obudowa przekładni Makita 413828-1 (stary numer 459216-8)

D8475

Title	Change of Brush A complete, Gear housing, Brush stopper Addition of Earth plate A
Model	DSL800, XLS01
Country	All countries
Description	For countermeasure against static electricity: • Brush A complete, Gear housing and Brush stopper will be changed. • Earth plate A will be added.

[2] Change of Gear housing

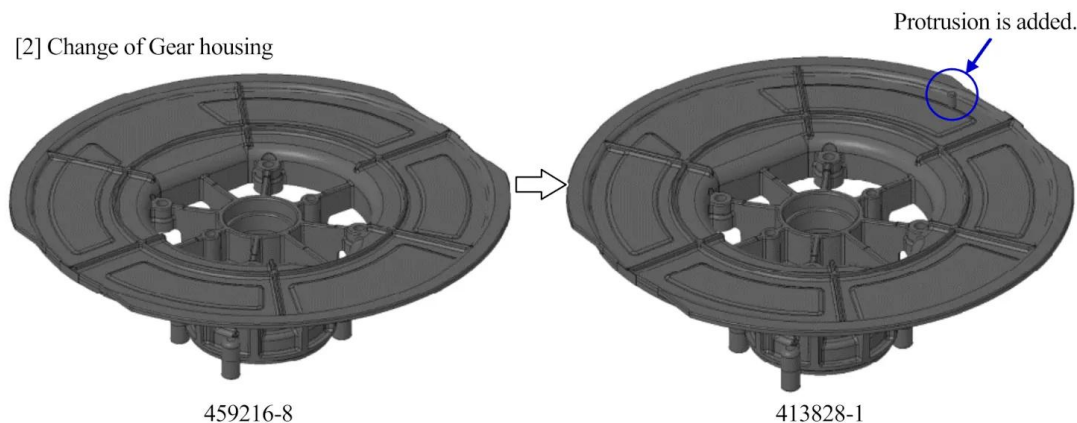
[1] Change of Brush A complete

Item No.	Current part	Q'ty	I/C	H/S	S/P	New part	Q'ty	Note
[1]	043	BRUSH A COMPLETE 140J85-5	1	S	OK	A	BRUSH A COMPLETE 141C96-1	1	Interchangeable as a set
[2]	029	GEAR HOUSING 459216-8	1	S	OK	A	GEAR HOUSING 413828-1	1	
[3]	040	BRUSH STOPPER 459219-2	1	S	OK	A	BRUSH STOPPER 413829-9	1	
[4]	094			S			EARTH PLATE A 347816-5	1
